Access Compliance Report

Public Rights-of-Way

Intersection ID: N/A	Main Street:	Cross Street: N/A	Location: N/A
ADA ID: 7537C4C1B872	Signal Type: One Push Button-APS	Overall Compliance: No	Severity Score: BTN 1: N/A BTN 2: N/A No BTN: N/A
Codes/Mitigation Info/Possible Solution		Field Measurements/Component Compliance

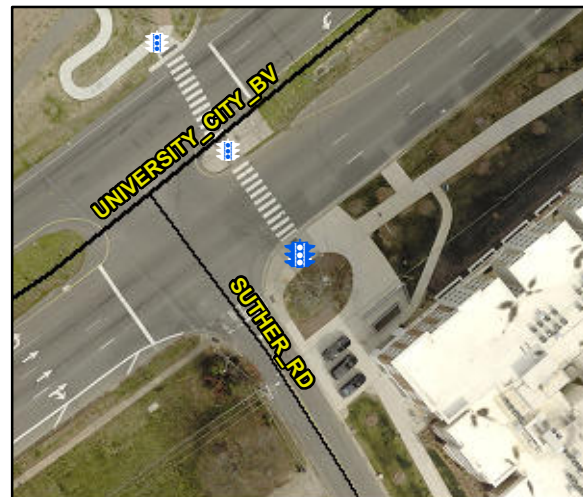
Surveyor Notes: N/A

N/A	B 1 Clear Xing Direction?	Yes	N/A	B 2 Clear Xing Direction?	N/A
	B 1 Crossing Direction	To NW		B 2 Crossing Direction	N/A
Yes	B 1 DistanceTo XWalk (in)	0.0	N/A	B 2 DistanceTo XWalk (in)	N/A
No	B 1 DistanceTo Curb (in)	136.0	N/A	B 2 DistanceTo Curb (in)	N/A
Yes	B 1 Diameter (in)	2.0	N/A	B 2 Diameter (in)	N/A

Possible Solutions: Replace Signal Push Button With APS Button on New Post. Remove & Relocate Sign.
